Re: SEQR Lead Agency Response – Brooks Landing Phase II
City of Rochester, Monroe County

CITY SITE PLAN / TRAFFIC IMPACT REPORT REVIEW COMMENTS

To: JASON HAREMZA, AICP, SENIOR PLANNER
FROM: BRENT H. PENWARDEN III, P.E., ASSOCIATE ENGINEER
DATE: JANUARY 4, 2012
RE: ***BROOKS LANDING – PHASE 2 - SITE PLAN AND UPDATED TRAFFIC DATA***

To: Jason Haremza, Zoning Division
From: Bill VanDame, Permit Coordinator
Date: January 4, 2012
Subject: Brooks Landing Phase II SEQRA Referral (File SP -014-11-12)

City of Rochester Water Bureau Maps & Records 10 Felix St Rochester, NY 14608-1031 (585) 428-7562 January, 2012 not for public use

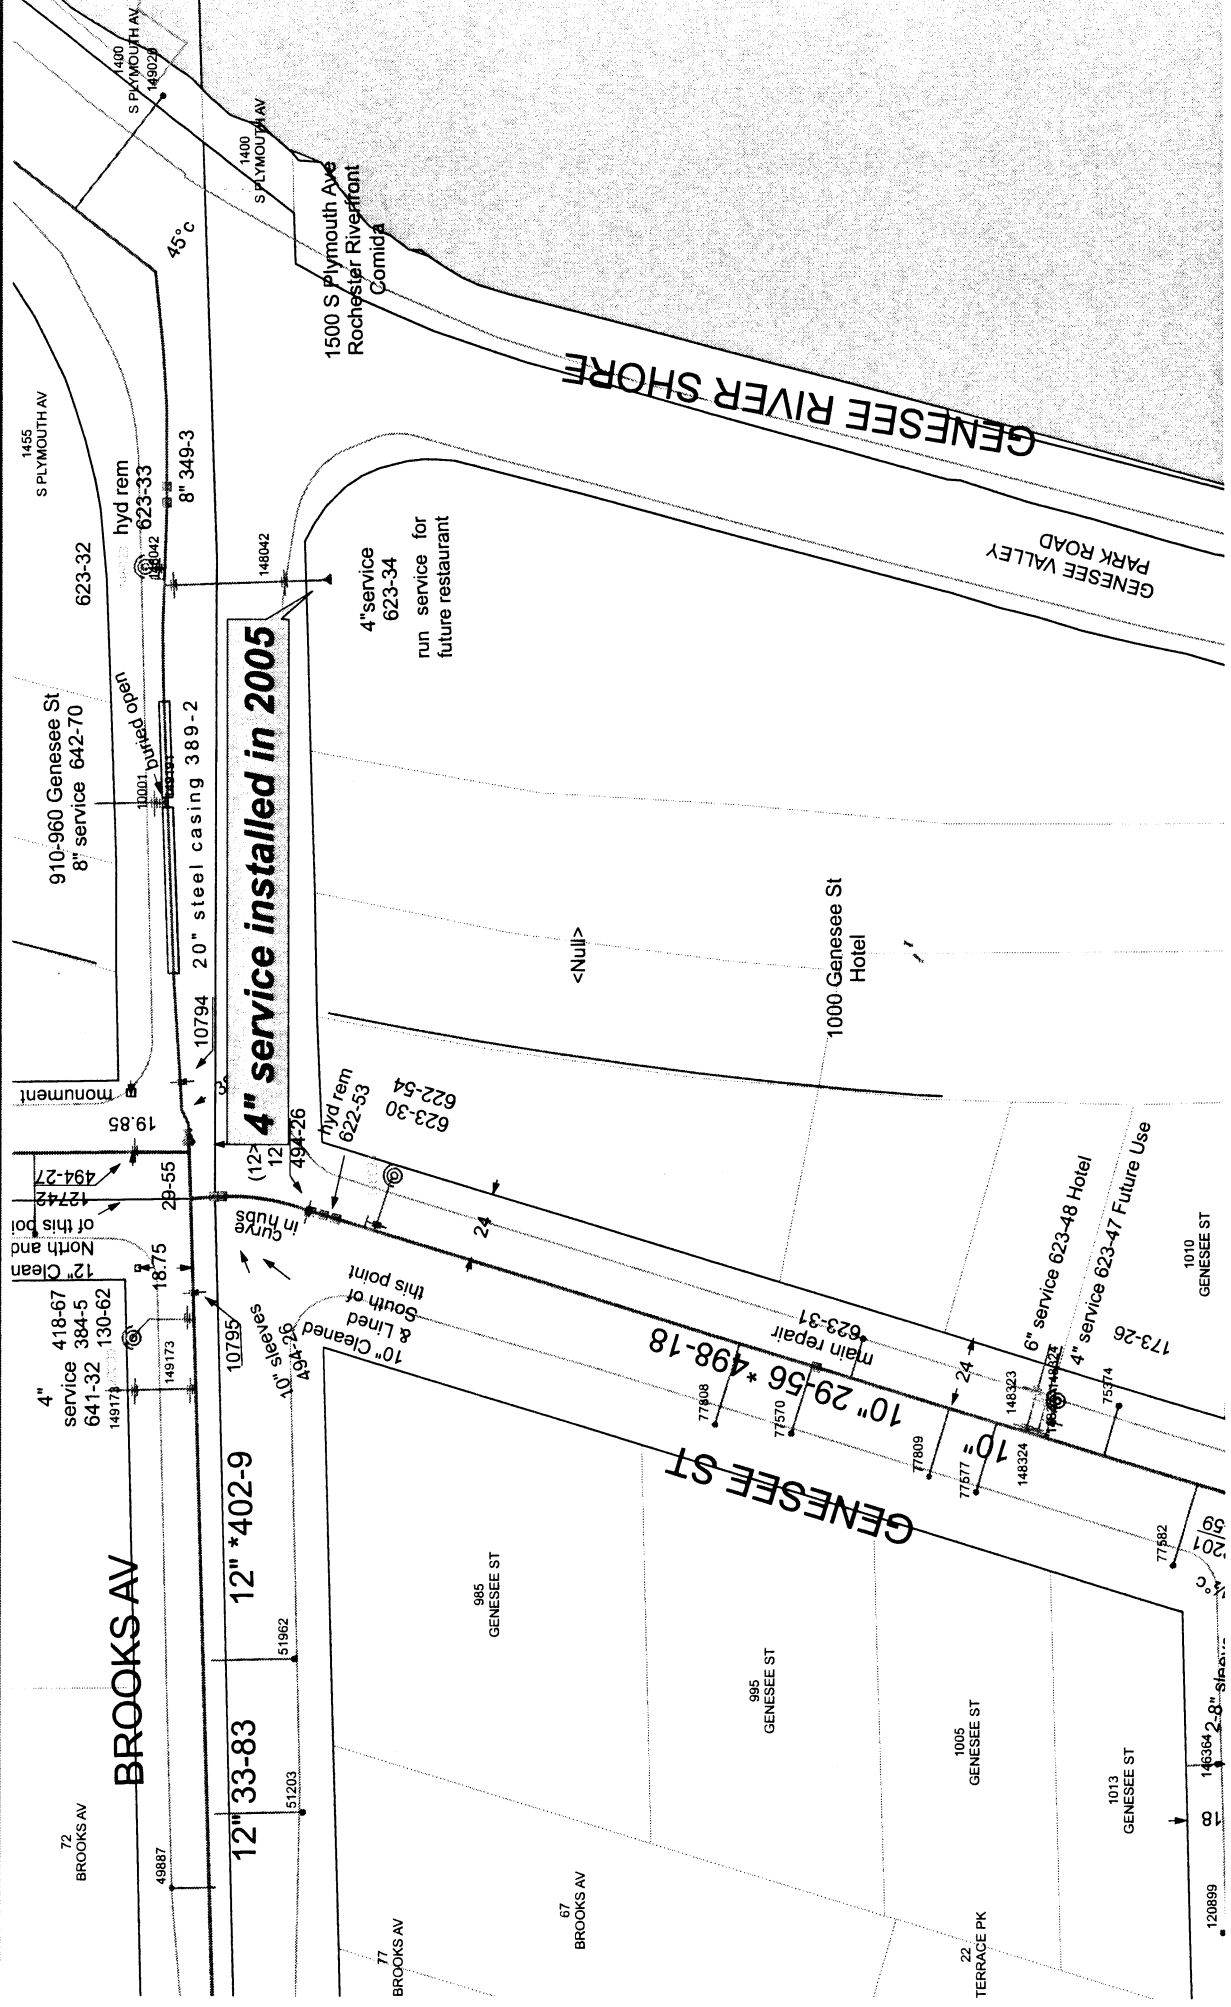
1. The bank will need a separate service. The bank cannot share a service with the restaurant.
2. A 4" service, designed and installed in 2005, already extends into the property from South Plymouth Avenue. Please refer to the attached map.
3. If the proposed bank parking lot prevents construction of the future restaurant, the owner will be required to reimburse the Water Bureau for abandoning the 4" service.
